| AMENDMENT OF SOLICITATION/MODIFICATION OF CONTRACT | | 1. CONTRACT ID CODE | PAGE 1 OF 4 PAGES |
| 2. AMENDMENT/MODIFICATION NO. Contract Modification No. 012 | 3. EFFECTIVE DATE See Block 16c | 4. REQUISITION/PURCHASE REQ. NO. | 5. PROJECT NO. (If applicable) North Bend Road OR PFH 97-1(8) |

| CONTRACT MODIFICATION | | | |
|--|--|------------------|-------------------------|
| STANDARD FORM 30 CONTINUATION SHEET | CONTRACT MODIFICATION NUMBER CM #012 | PAGE 2 | OF PAGES 4 |

This contract modification definitizes Contract Modification #011.

VEE DITCH

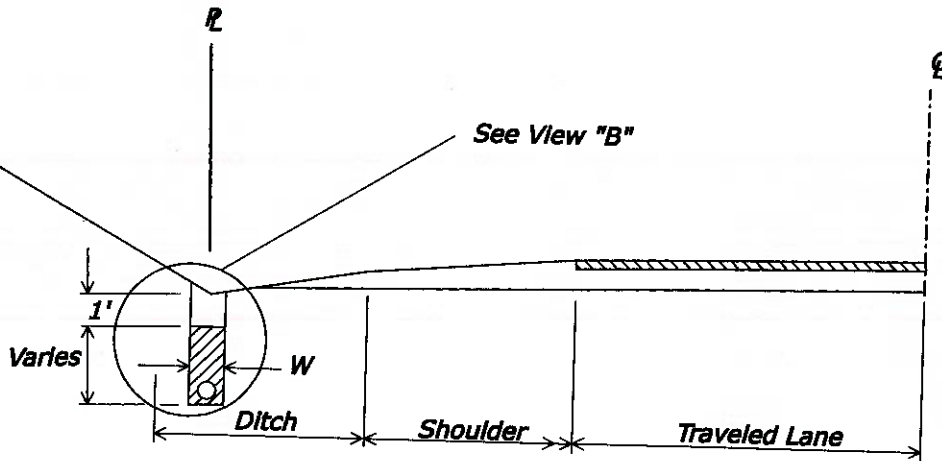
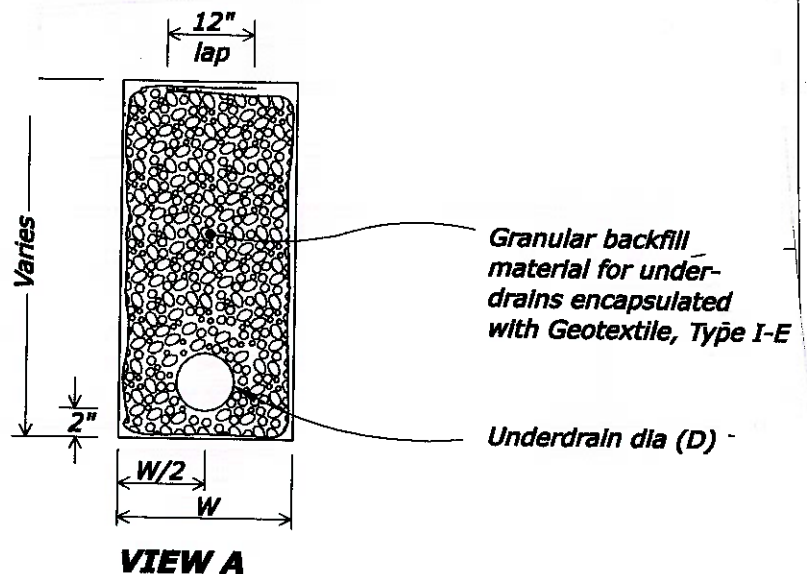
This modification calls for the installation of an underdrain system to handle subsurface water encountered between Sta. 126+50 Lt. and Sta. 131+00 Lt. It also modifies to the culvert inlet at Sta. 128+25 Lt. to accommodate the underdrain outlet pipes.

This work also consists of furnishing and install underdrain systems using pipe, granular backfill, permeable backfill and geotextile.

1. Location of pipe underdrains may be adjusted by the CO.
2. Minimum underdrain grade is 0.5 percent.
